APPLICATION NO.	FILING DATE	FIRST NAMED INVENTOR	ATTORNEY DOCKET NO.	CONFIRMATION NO.
09/843,637	04/26/2001	Shuhei Marukawa	10873.703US01	9215

**Office Action Summary**

MARUKAWA ET AL.

F I G. 4

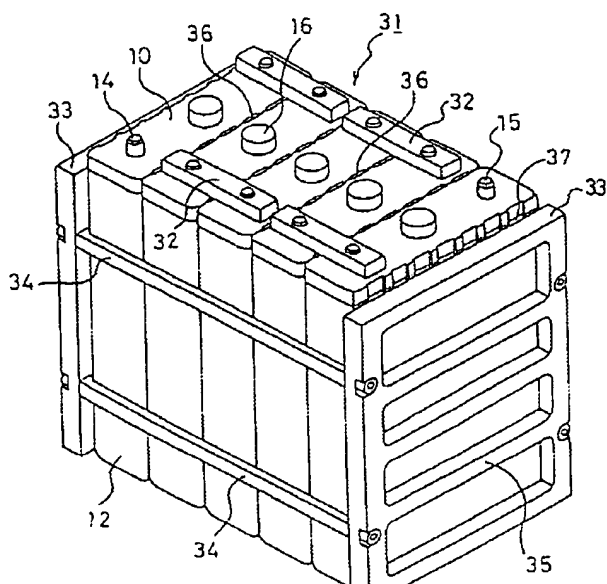
With regards to claim 2, it is noted from a comparison of Figs. 3 and 4, that the cells include a plate group, and the cells and the electrode plate groups are stacked in the same direction.
